RESPONSE LETTER NO. 2 TO REQUEST FOR INFORMATION

Project Title: **Roadway Improvements to NW 37th Avenue from NW 36th Street to NW 79th Street**

Project No.: **20210093 (Capital)**

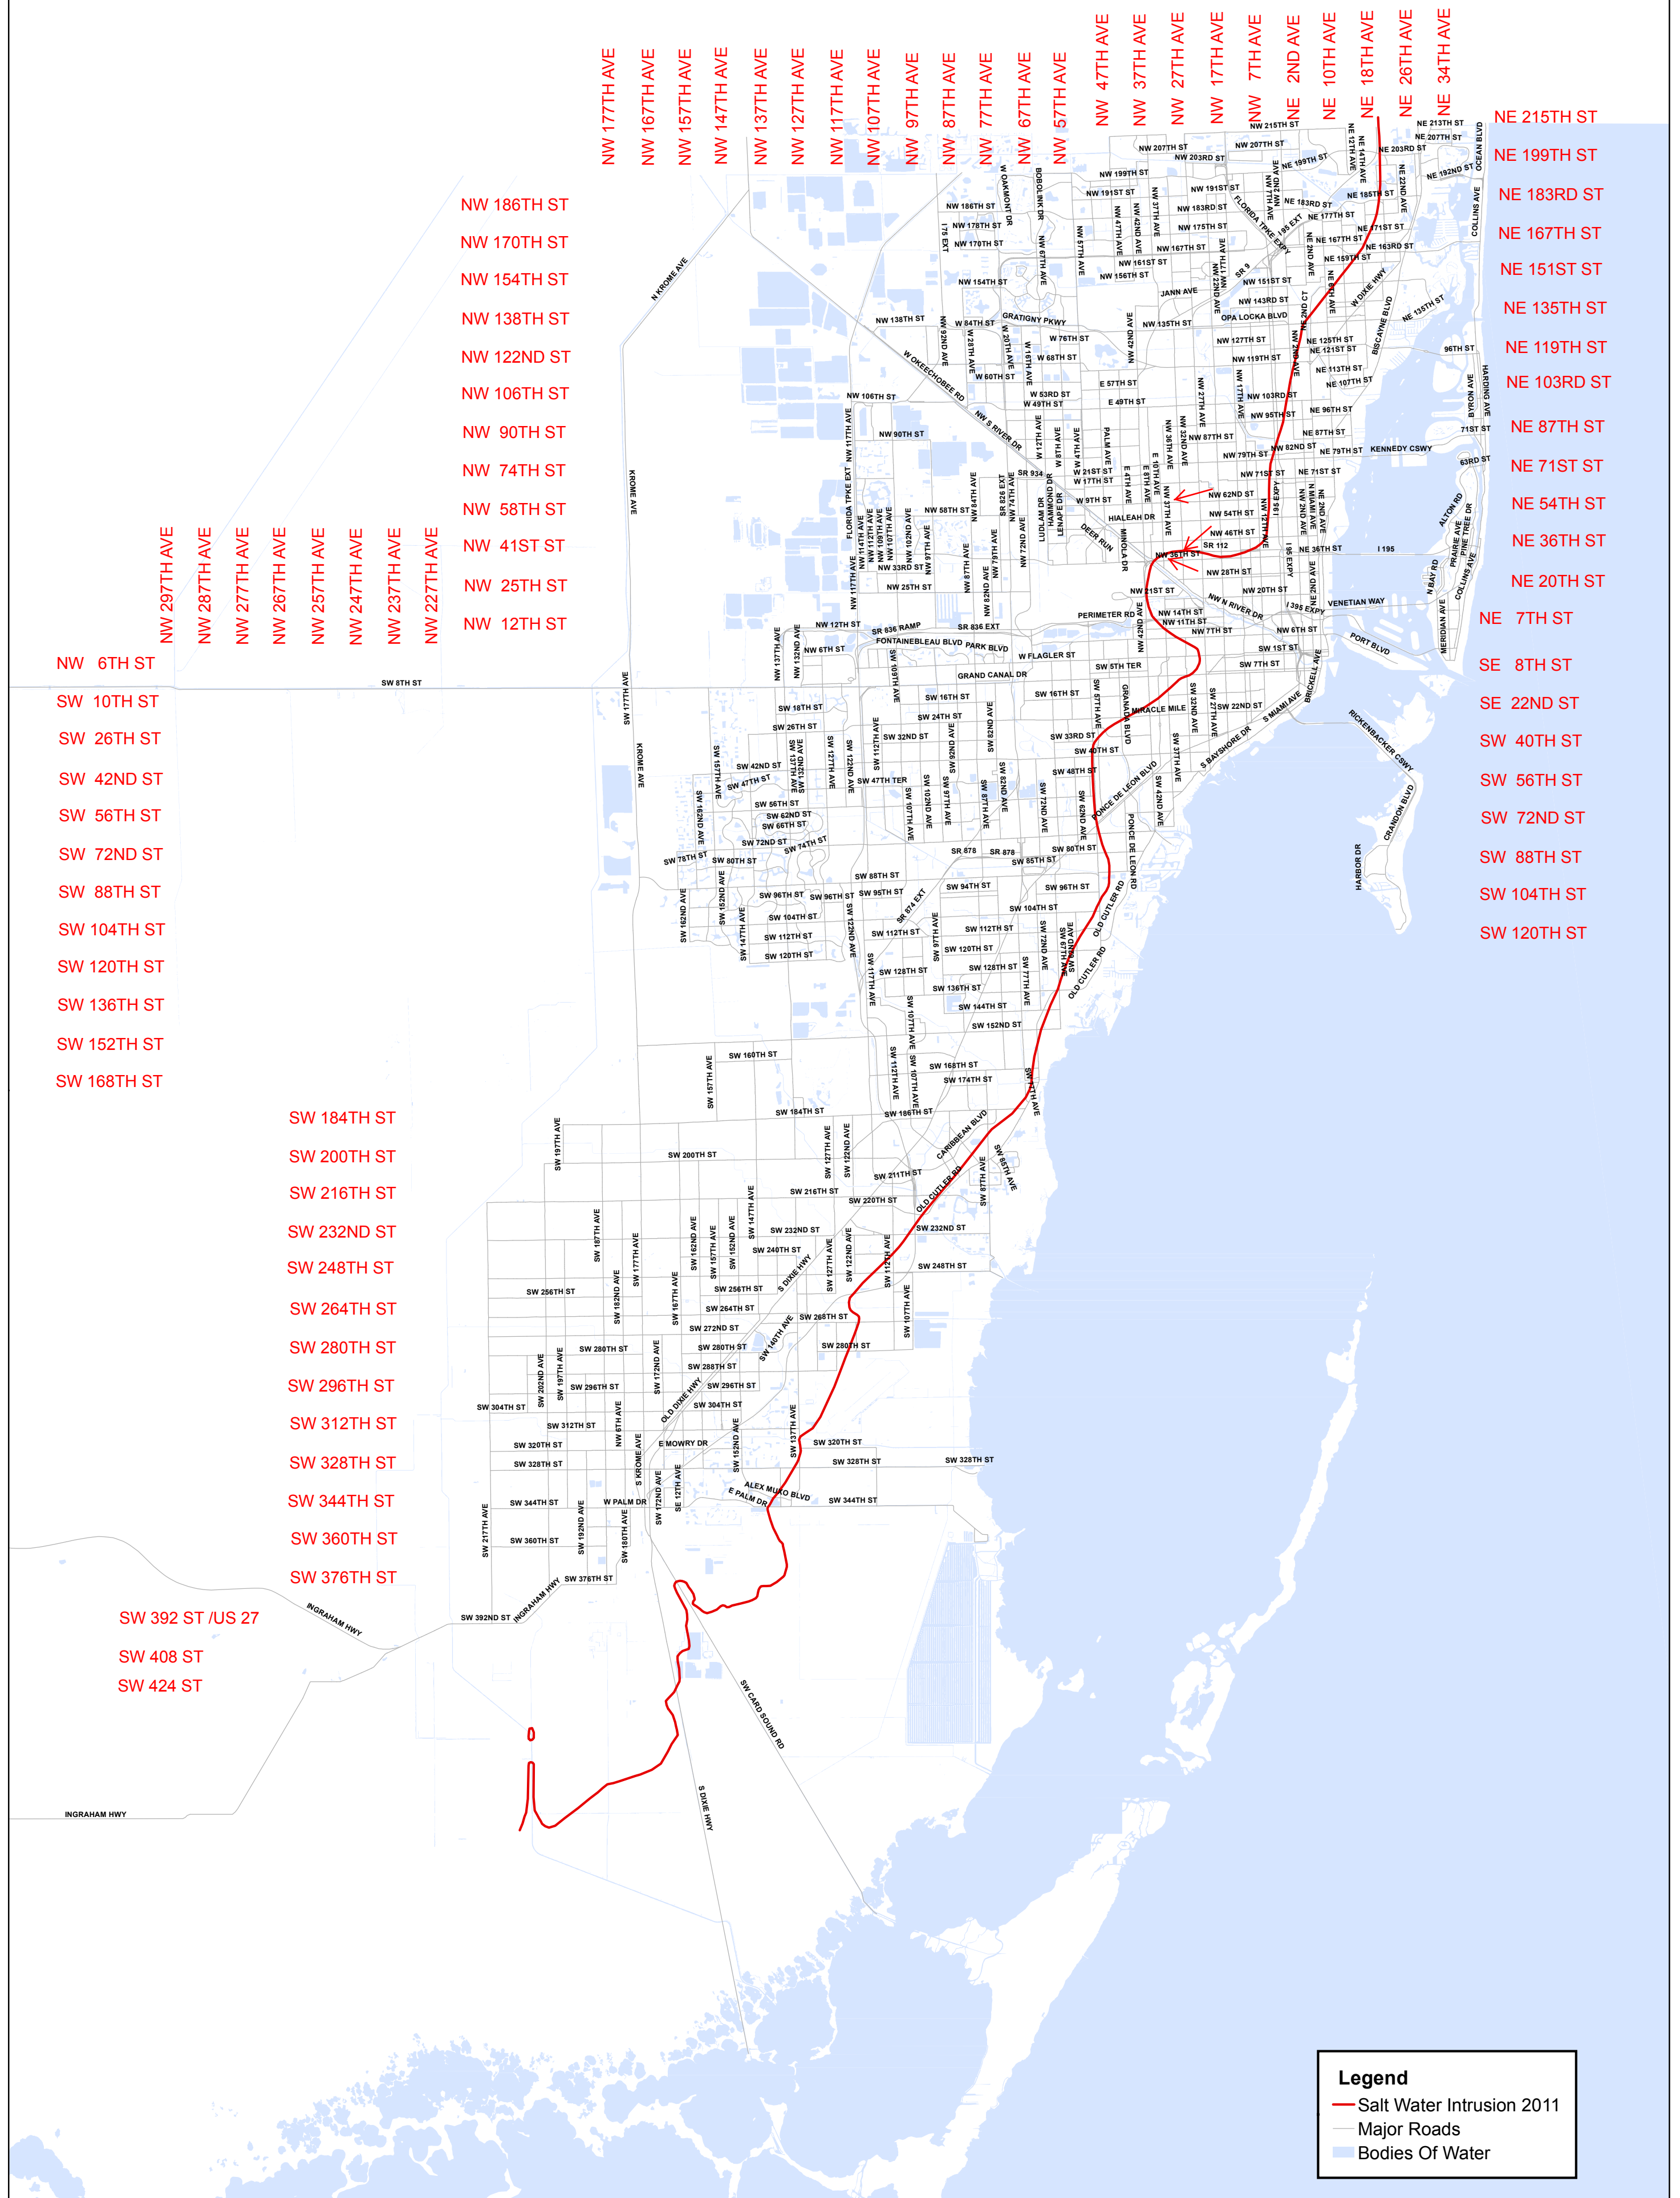
Per the saltwater intrusion map it appears that the zone ends somewhere around the SR112 overpass or roughly 800-1000' max from 36st. But the plans call for like 5500' of 16" zinc pipe and fittings? We need exact parameters marked on the plans or something, if possible, to quantify the zinc fittings required as those cost more than non-zinc fittings just like the pipe.

RESPONSE: 1) Zinc coated pipes limits were considered from NW 36 ST to NW 54 ST due to the proximity to salt intrusion area and soil corrosivity.

VOLUME V

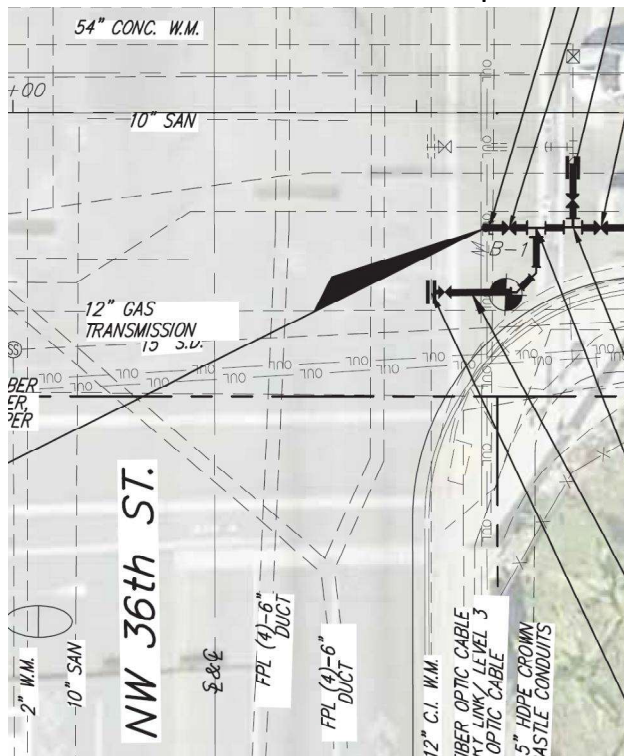
- 33) Vol 5- WASD WM PLANS, PDF page 38 shows start of work at Sta 20 51 with a 12” tap, does the work at this location requires DOT full intersection restoration?

RESPONSE: 33) Please note that this project involves not only installation of proposed Water/Sewer improvements from NW 36 ST to NW 82 ST, but Roadway/Drainage/Lighting improvements as well from NW 36 ST to NW 79 ST. Please refer to Volume III, page 14 to see proposed complete milling and resurfacing at intersection of NW 37 Ave and NW 36 ST.

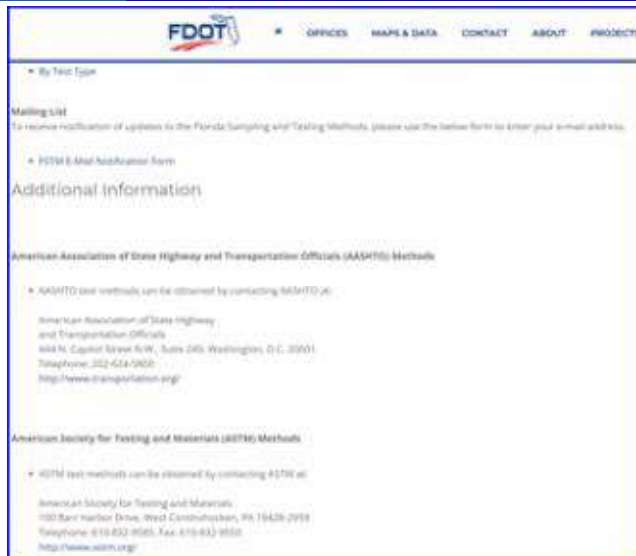
- 47) Testing of the drainage pipe was only found on Volume I, PDF page 286 where it directs you to DOT website link "o. Florida Department of Transportation Florida Sampling and Testing Methods"
<http://www.fdot.gov/materials/administration/resources/library/publications/fstm/disc>

page. Can you please clarify the testing requirements for the drainage system?

- RESPONSE:** 47) For drainage system testing requirements, please refer to FDOT Standard Specifications for Road & Bridge Construction, Section 430-4.8 thru 430-4.8.2
